LIGHTNING F MK. 2

LIST OF LETTERED ADDENDA  
(EJECTION SEAT MK. 4BSA)

## Addendum A

**EJECTION SEAT MK. 4BSA MOD. NO. 2690**  
(Introduction of downward pull negative-G restraining strap)

(5) Fig.3. Arrangement of negative-G restraining strap on P.S.P Disregard Fig. 3 in Chapter 2 and refer to Fig. 1 of this addendum.

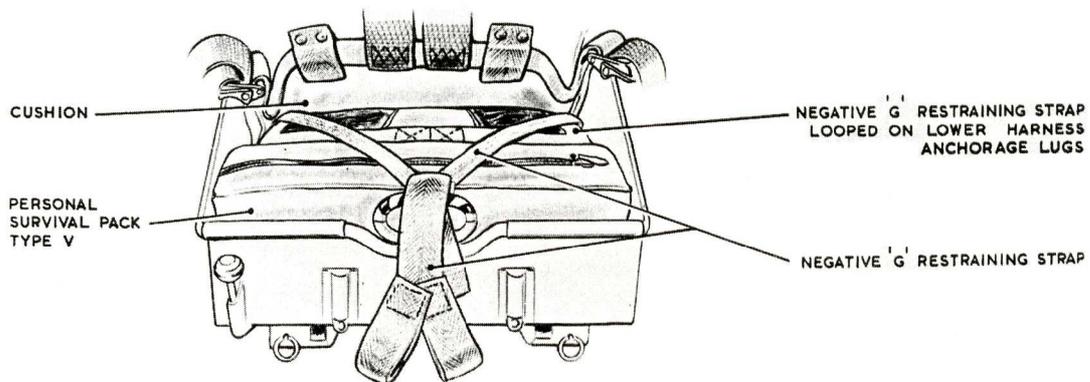
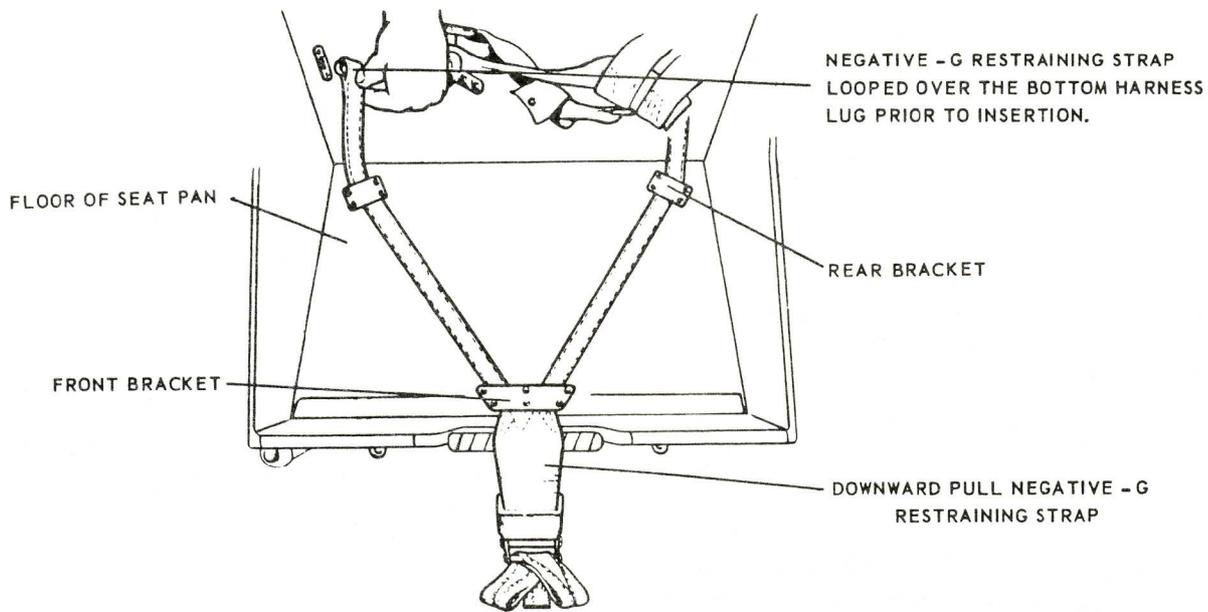
1 Modification E.S. 2690 introduces a downward pull negative-G restraint strap in lieu of the upward pull strap introduced by modification P.A. 69.

(d) Drape the blue 'Y' piece of the negative-G strap OVER THE TOP of the seat pan firing handle.

Fig. 1 Arrangement of downward pull negative-G restraining strap in seat pan

Fig.7 Arrangement of negative-G restraining strap to lap straps. Disregard Fig. 7 in Chapter 2 and refer to Fig. 2 of this addendum.

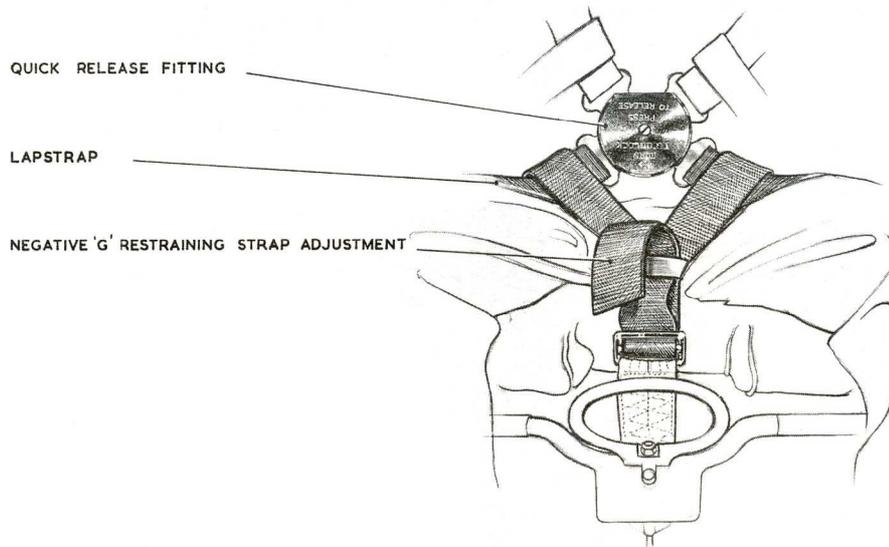
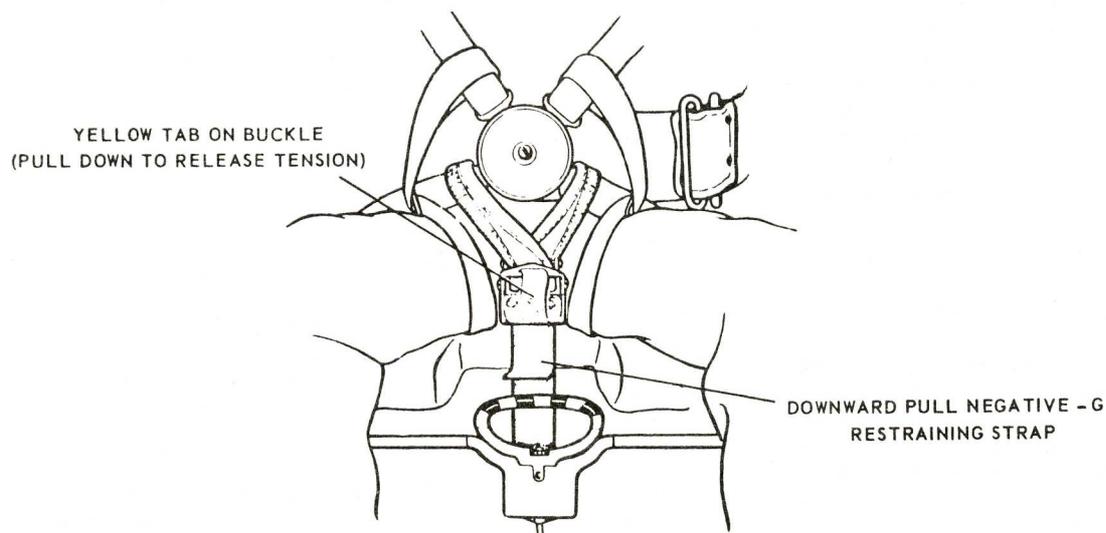
Tighten the negative-G restraint strap by pulling DOWNWARDS on the free end of the blue strap until the strap is as tight as possible and ensure that the free end is then tucked down BEHIND the alternative firing handle. The strap is fitted with a snubber, which is released by pulling downwards on the yellow tab attached to the snubber lever, to loosen the strap.

Fig. 2 Arrangement of downward pull negative-G restraining strap to lap straps
